From: Joyce Christie
Sent: 21 October 2020 15:33
To: Gemma Magnuson <Gemma.Magnuson@cherwell-dc.gov.uk>
Subject: 20/00948/LB Temple Mill

Elevation:

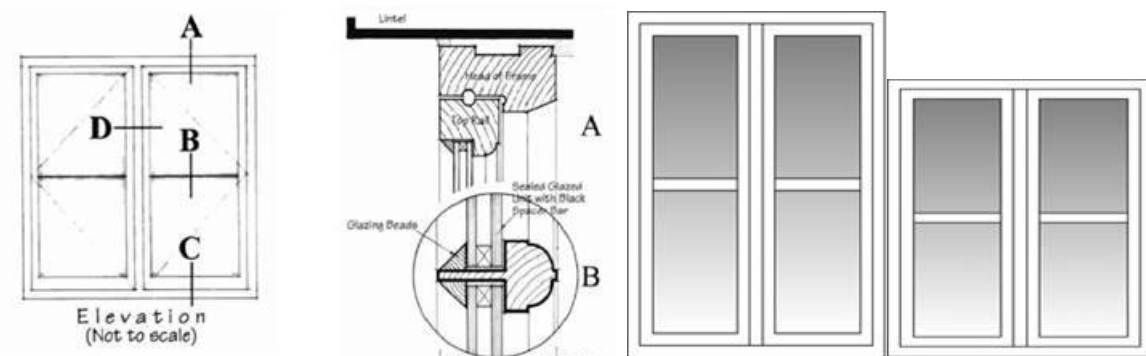
Although I think it still looks very bitty, it might be acceptable if the taller roof looks as if it is supported on something, this also helps the proportions/width of the taller element. The wide opening without support does not look structurally believable for a timber beam and would look better with the post/staddle stone as originally proposed, including the central post:
